Product Change Notification

Product Change Notification: E-20-017968

AMPSEAL 14-Position Vertical and Right-Angle Header Counterbore Addition

AMPSEAL Counterbore Before & After Illustration

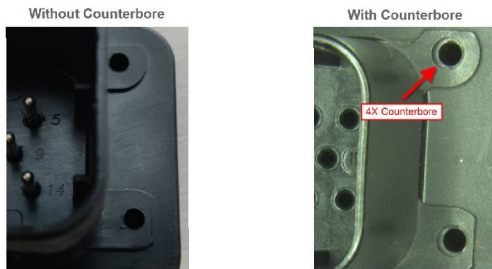
The Industrial and Commercial Transportation business unit of TE Connectivity is making a change to the mounting hole geometry on all 14-position vertical and right-angle AMPSEAL headers for the part number(s) listed below. These PNs are TE proprietary designs, therefore considered catalog/general market product. PPAP and/or sample requests must be submitted within 14 days of PCN submission via ict-ppap-request@te.com or ePPAP system. Submission will not occur without request. If PPAP requested, disposition response is required within 14 days of submit date or it will be considered approved. Product drawing(s) are affected.

Product Improvement. Dear Customer, we hereby inform you of this change. The change is necessary to improve mounting capabilities. The change does not impact performance. IMPORTANT: The current and previous revisions of these parts can be used interchangeably in the field. The change(s) are being phased in gradually and previous revision can remain stocked until use. Shipments of both configurations may be mixed.
